APPLICATION OVERVIEW
SKETCH PLAN REVIEW
ARTICLE 7, SECTION 7.3

| DRB DOCKET #: | DRB-20-03 |

| PROJECT DESCRIPTION: | The Applicant is seeking approval for a 2-Lot subdivision regarding land she owns at 8 Edgmont Road (ED008). |

BETSY EVANS
SKETCH PLAN REVIEW
Docket #: DRB-20-03

TABLE 2.7 – SOIL & WATER CONSERVATION

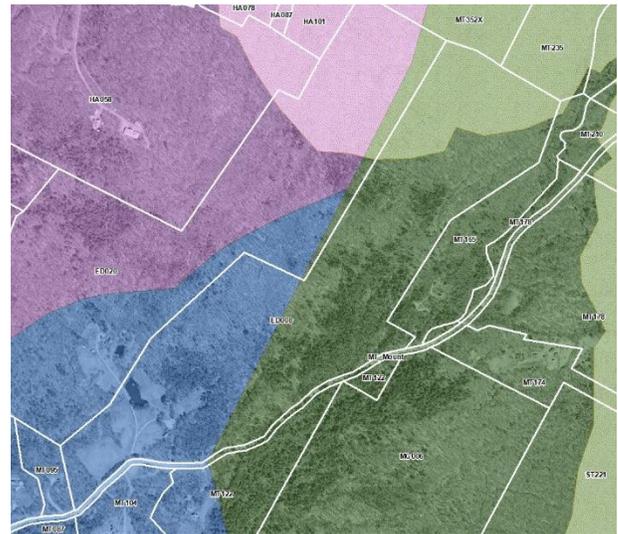
- The proposed lot appears to be configured in a way that will be located in both the Water Conservation and Soil & Water Conservation zoning districts.
- Should the construction of a single-family dwelling occur in the Soil & Water Conservation District of this lot the impact would be low, and consistent with nearby development.
- Upon the submission of engineering plans, Staff will have a better understanding of how the proposed development conforms with the purpose statement of this district.
- The northern area of the lot contains area above 1500 ft. in elevation (see directly to the right), where all new development is prohibited. New development is NOT anticipated to be proposed or located in this area.

SECTION 3.17 – SOURCE PROTECTION AREAS

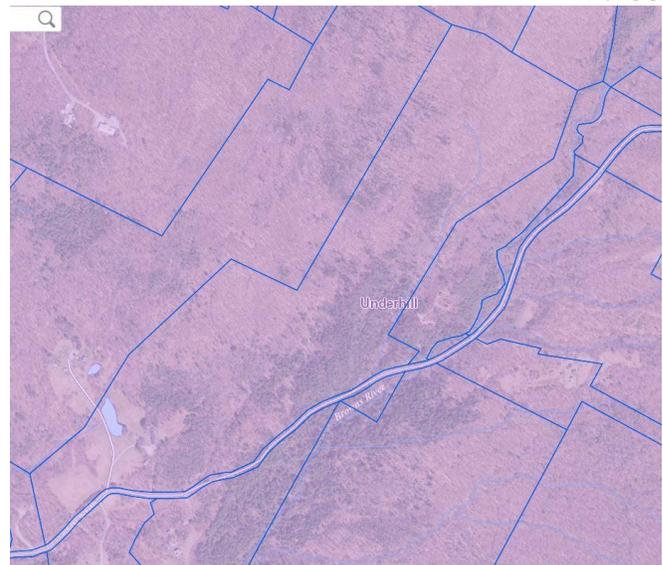
- The subject lot is located entirely within the Groundwater Source Protection Area.
- Avoiding the siting of an assumed single-family dwelling outside of this Source Protection Area is not feasible; however, single-family dwellings are exempt from requiring additional review under this Section per § 3.17.B.

SECTION 3.18 – STEEP SLOPES

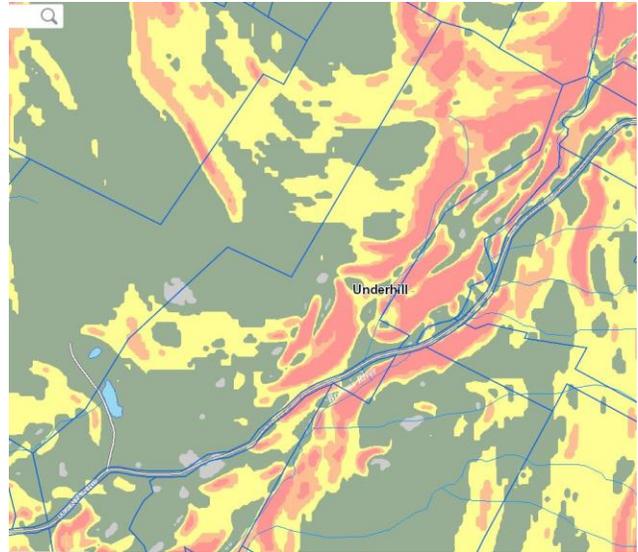
- Areas of steep slopes (15-25%) and very steep slopes (>25%) are present on the existing lot (see directly to the right).
- The proposed lot will contain areas of steep slopes and very steep slopes.
- Upon the submission of engineering plans, Staff will have a better understanding of how the proposed development driveway conforms with the requirements of this Section.

SECTION 3.19 – SURFACE WATERS & WETLANDS

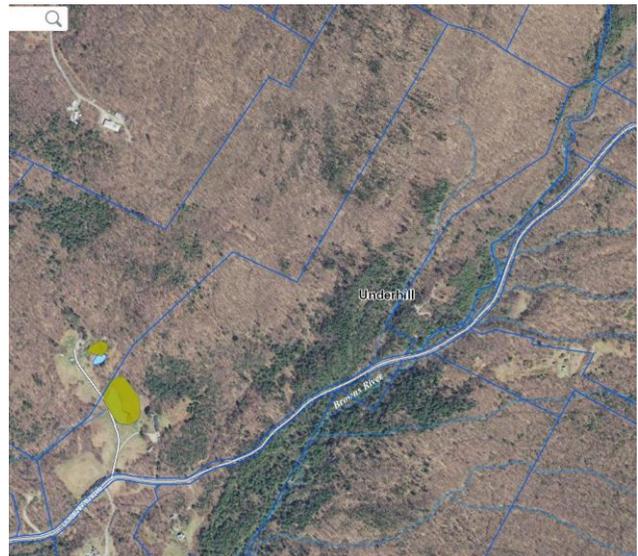
- An unnamed stream is located on the parent lot, which feeds the Brown’s River.
- The unnamed stream does not appear to bisect the proposed new lot, and therefore, no development is likely to be proposed within the stream’s vicinity.
- A pond and unnamed stream are located within the vicinity of the existing single-family dwelling, which will stay with the parent lot.
 - Staff is unaware of any new development in this area.
- An area of wetlands is located in the area where the pond is located, and not in the vicinity of the proposed new lot; therefore, any new development associated with the proposed new lot is not anticipated to impact any wetlands or associated buffers.
